<b>Subject:</b> WHITE MILKY STAINS ON INNER SURFACE OF HEADLIGHT LENS	<b>Bulletin No:</b> 09-014/16
	<b>Last Issued:</b> 03/14/2016

2013-2016 CX-5 vehicles with VINs between JM3KE\*\*\*\*\*486578 - 745219 (produced between May 28, 2014 and Nov. 23, 2015)

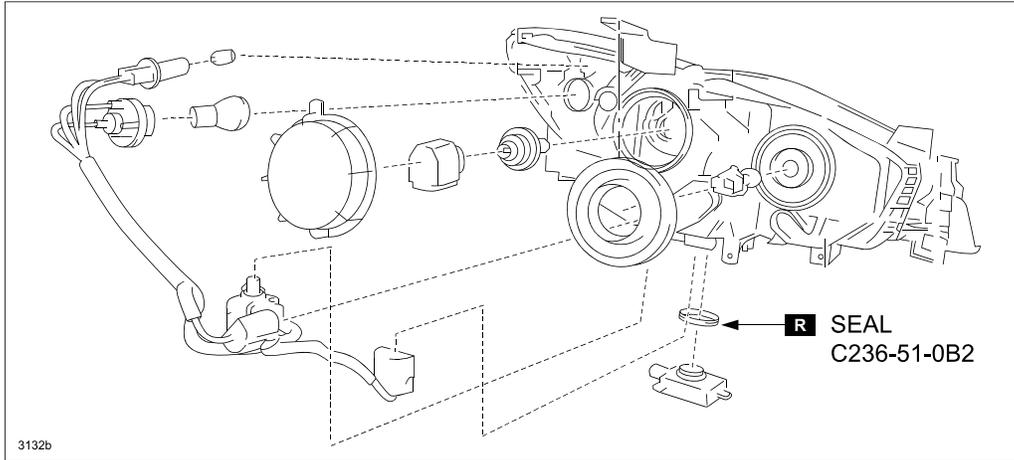
**NOTE:** Discharge Headlights Only: Be sure to replace the seal (shown below) with a new part.
